# National Transportation Safety Board

## Safety Recommendation

**In reply refer to:** A-04-42 and -43

Figure 3. Air Cruisers P/N 29984-series tailcone slide, revised per SB 304-25-24

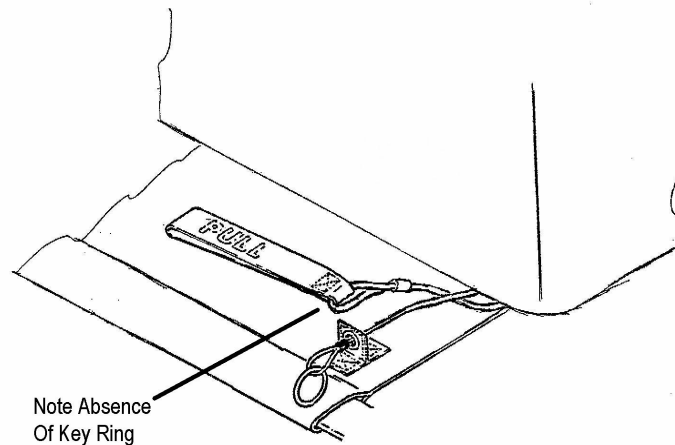
On April 27, 1992, Air Cruisers issued Service Bulletin (SB) 304-25-24 for P/N D29984-series evacuation slides manufactured before serial number 0940. The SB instructed operators to remove and discard cable assembly P/N 37028-105, which contained key rings attached to both the automatic and manual portions of the inflation cable (as shown in figure 1), and install new cable assembly P/N 61866-101, which contained a key ring attached to the automatic cable but not to the manual cable (as shown in figure 3). On the new cable assembly, the red “PULL” handle is attached directly to the manual portion of the cable. The SB also stated that Air Cruisers “folding procedure P-11843 will require a revision as a result of this service bulletin.”

This investigation identified numerous instances in which Air Cruisers P/N D29984-series slides were installed on American Airlines airplanes with improperly rigged cable assemblies and in which newer style cable assemblies had been improperly modified. The Safety Board is concerned that these latent failure modes very likely exist on other MD-80 and MD-90 airplanes in the U.S. fleet and would likely render an important escape route unusable during an emergency evacuation because of an uninflated slide. As a result of this concern, the Board considers it critical that the FAA specifically target and rectify the improperly rigged/modified slide problem expeditiously, rather than waiting for a normal cycle of slide maintenance to transpire. Therefore, the Safety Board believes that the FAA should expeditiously issue an airworthiness directive to require operators to implement Air Cruisers SB 304-25-24 on an accelerated schedule and not wait for the slides' next regularly scheduled maintenance interval. Further, because maintenance personnel at other airlines may have improperly modified new P/N 61866-101 inflation cables (as American Airlines personnel did) due to the misleading packing instructions, the Safety Board believes that the FAA should require operators that are operating airplanes with slides with P/N 61866-101 inflation cables that have been improperly modified to include a manual inflation cable handle with a key ring, to reinstall new, unmodified P/N 61866-101 inflation cables (in which the manual inflation handle does not include a key ring) at the next scheduled maintenance opportunity.

Expediently issue an airworthiness directive to require operators to implement Air Cruisers Service Bulletin 304-25-24 on an accelerated schedule and not wait for the slides' next regularly scheduled maintenance interval. (A-04-42)

Require operators that are operating airplanes with slides with part number 61866-101 inflation cables that have been modified to include a manual inflation cable handle with a key ring, to reinstall new, unmodified part number 61866-101 inflation cables (in which the manual inflation handle does not include a key ring) at the next scheduled maintenance opportunity. (A-04-43)
